Memo

To: Bendigo-Ophir Gold Project Expert Panel **Cc:** Environmental Protection Authority

Subject: **Joint Response to Panel Request for Information 4 – Geology, Geotech, Engineering**

Figure F6: Unlikely Case – Post-closure Conditions

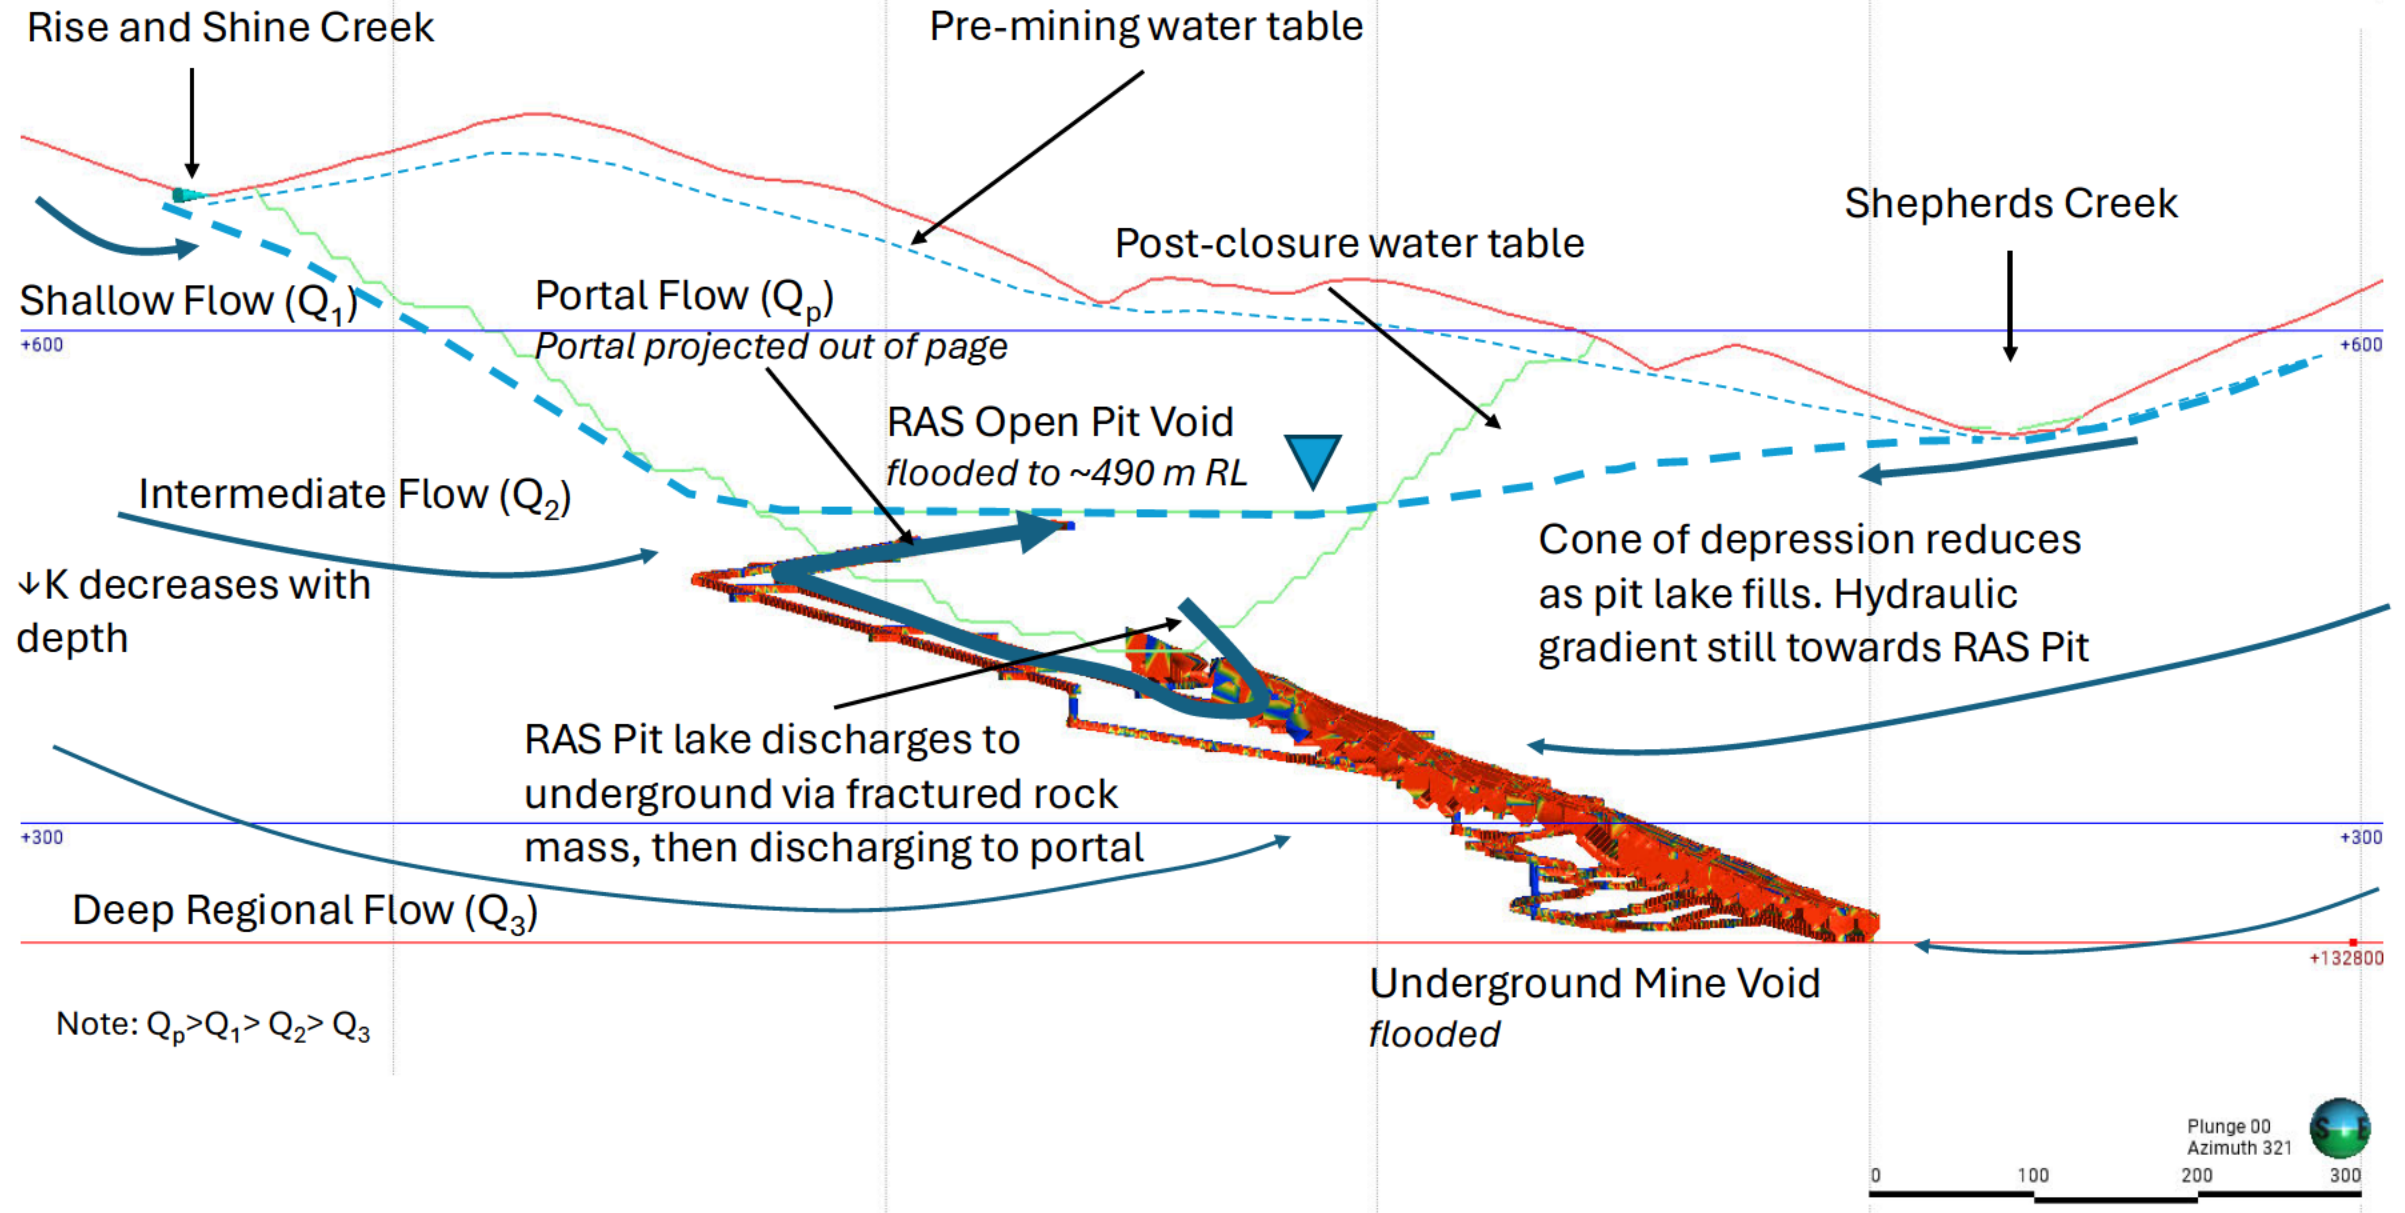
93. For the Unlikely Case, under Post-closure Conditions, interception of seepage bypass within the schist bedrock if bypass were to occur similarly to under Operational Conditions (Figure F6).

Figure F7: RAS Pit Lake groundwater conceptual model

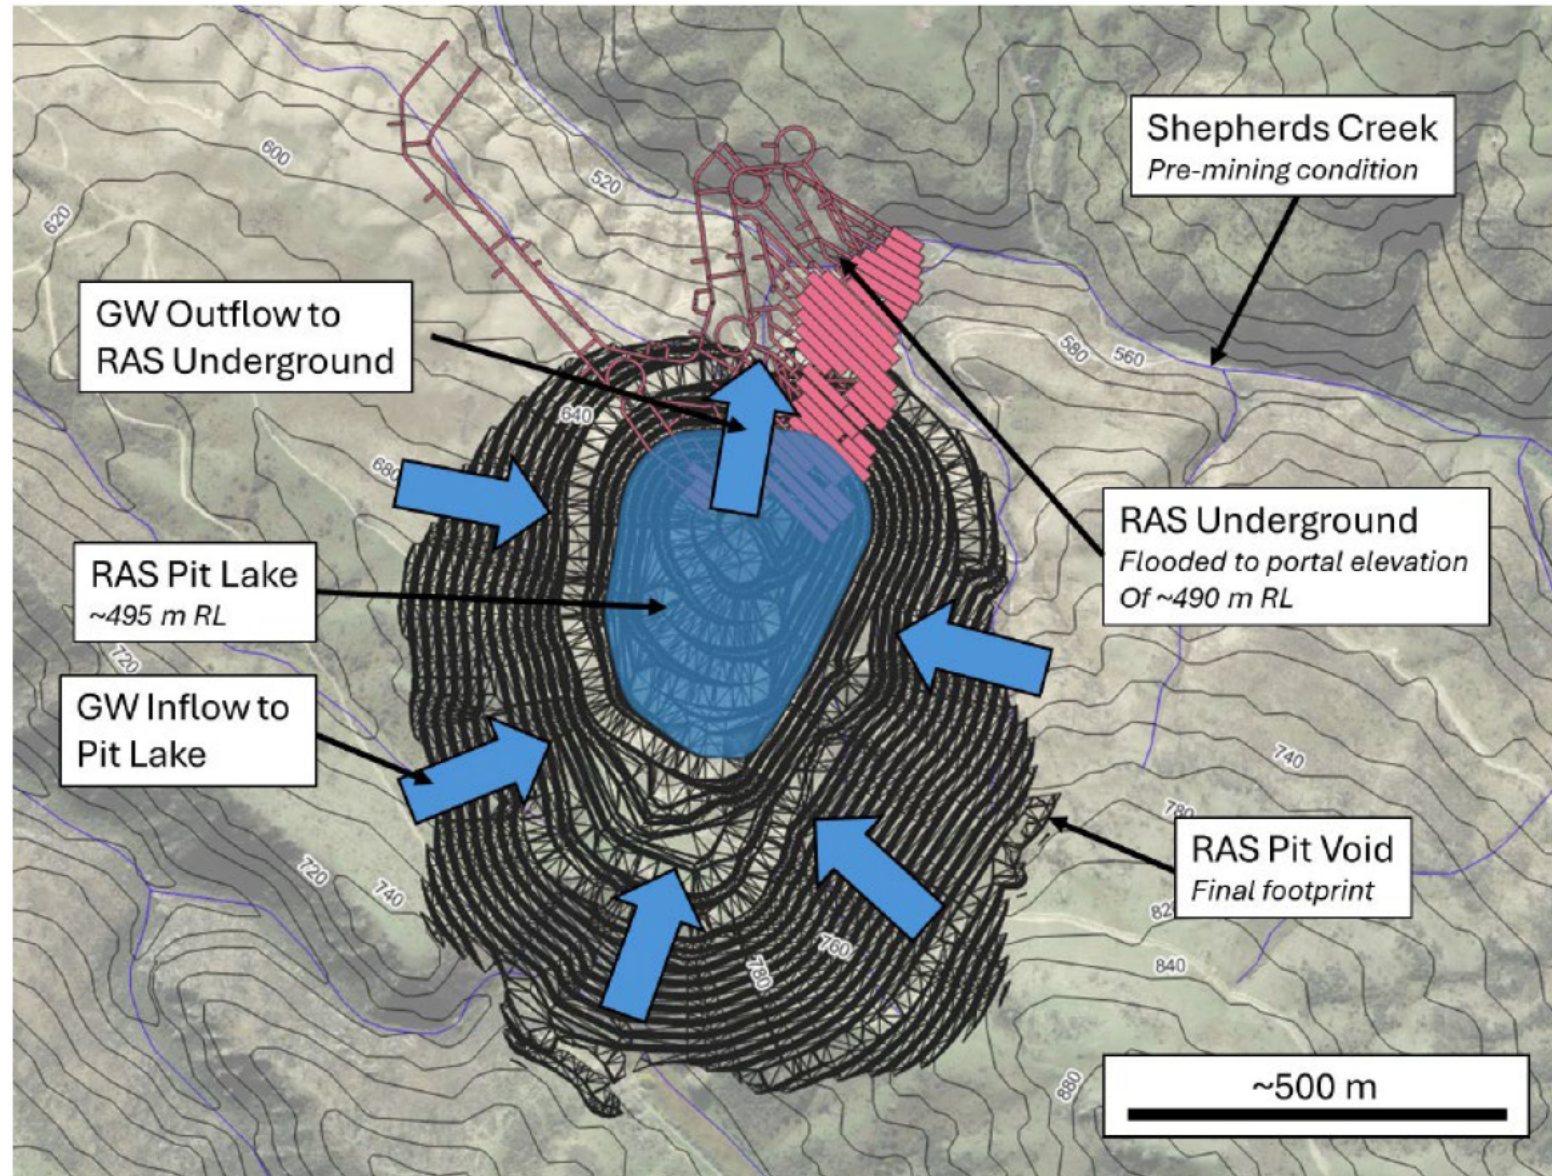
94. The vast majority of the RAS Pit void water at closure would discharge to the Underground workings through the fractured rock mass above the crown pillar (now removed under post-closure conditions). All other quadrants surrounding the pit lake would have a hydraulic head higher than the pit lake level implying inflow (Figure F7).
